CITY OF HUNTINGTON BEACH

**CITY OF HUNTINGTON BEACH
REQUEST FOR CITY COUNCIL ACTION**

SUBJECT: APPROVE MITIGATED NEGATIVE DECLARATION NO. 03-08
(Good Shepherd Cemetery - Appeal)

ENVIRONMENTAL CHECKLIST FORM
CITY OF HUNTINGTON BEACH
PLANNING DEPARTMENT
ENVIRONMENTAL ASSESSMENT NO. 03-08

EXHIBIT 1 – Original Design (Applicant)

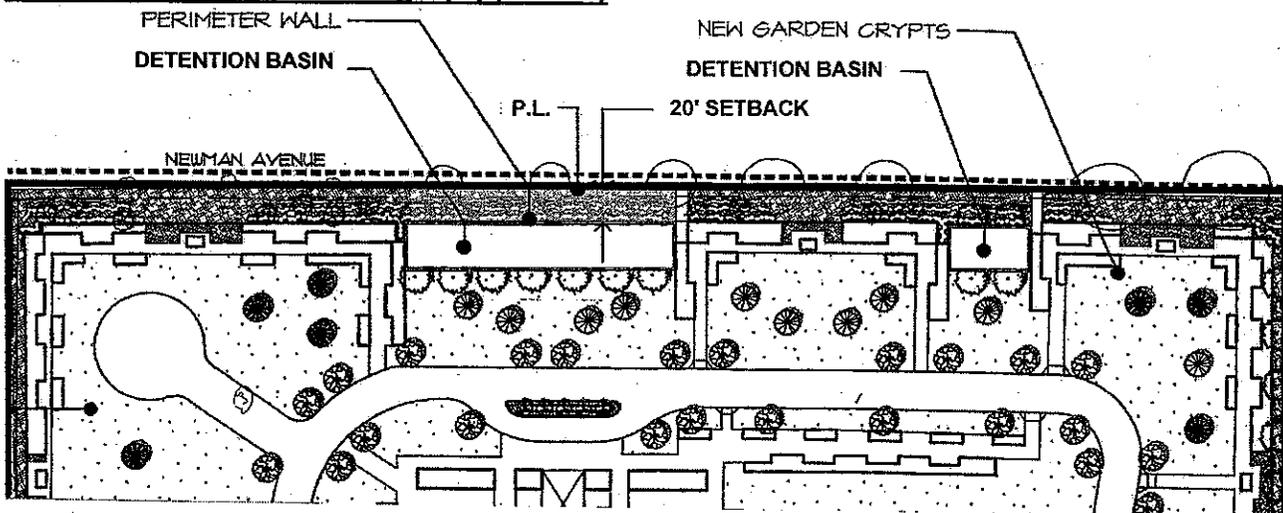
On November 19, 2004, the applicant appealed the Planning Commission's approval of Mitigated Negative Declaration No. 03-08. The basis for the appeal is the applicant's objection to the mitigation measure and the required design of the detention basins with a 5 to 1 earthen slope. The mitigation measure would require more land on-site and reduce the land available for future interment (see Attachment No. 5).

The applicant's original proposal to address the mitigation measure consisted of two detention basins with vertical concrete walls located in-line with the garden crypt buildings along Newman Avenue. The basins were surrounded by six-foot tall concrete block walls and were setback 20 feet from the northerly property line. The detention basins were approximately 206 ft. by 57 ft. and 61 ft. by 37 ft. respectively. Exhibit 1 below illustrates the original design of the detention basins:

EXHIBIT 2 – Revised Design

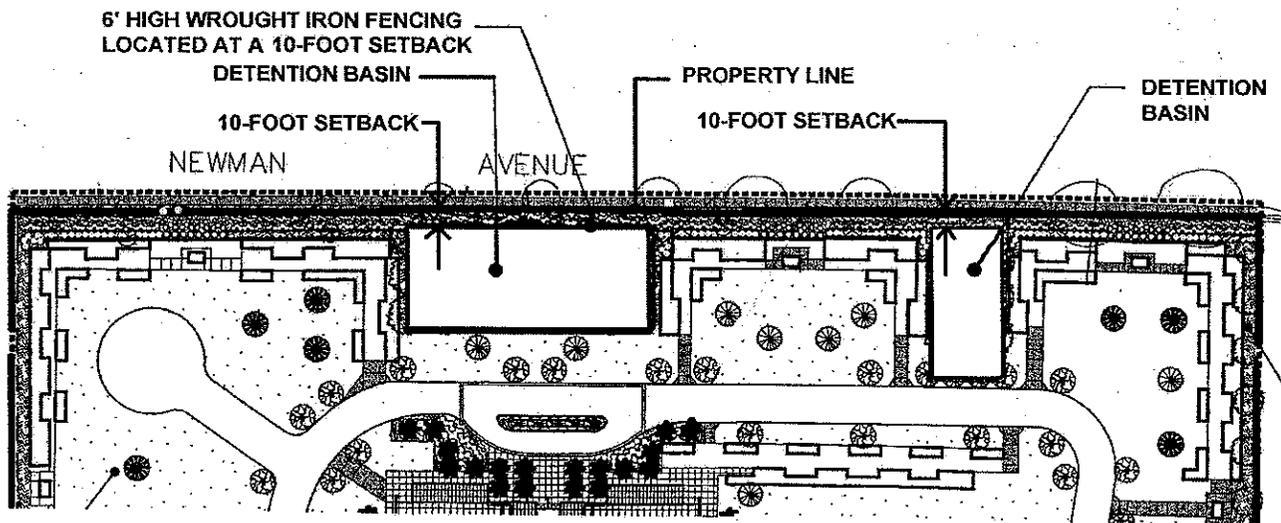
The revised proposal consists of two detention basins in approximately the same location but at a minimum code required setback of 10 feet in lieu of the originally proposed 20 feet. The detention basins have increased in size to accommodate the 2 to 1 earthen slopes. The basins now measure approximately 197 ft. by 90 ft. and 60 ft. by 132 ft. respectively. The depth of the basins range between approximately 6.5 feet to 6.7 feet. As a result of the depths of the basins, a six-foot high wrought iron fence is required around the perimeter of the detention basins in accordance with the Uniform Building Code. The following exhibit illustrates the revised design:

The bottoms of the detention basins will be planted with ground cover and the slopes will be landscaped with ground cover, low shrubbery, and trees. As shown in Exhibit 2, a perimeter wrought iron fence surrounds the detention basins.

Staff supports the revised mitigation measure based on the proposed design of the detention basins with earthen slopes. The revised mitigation measure is consistent with the findings of the MND and the CUP and will provide a compatible and aesthetic design solution consisting
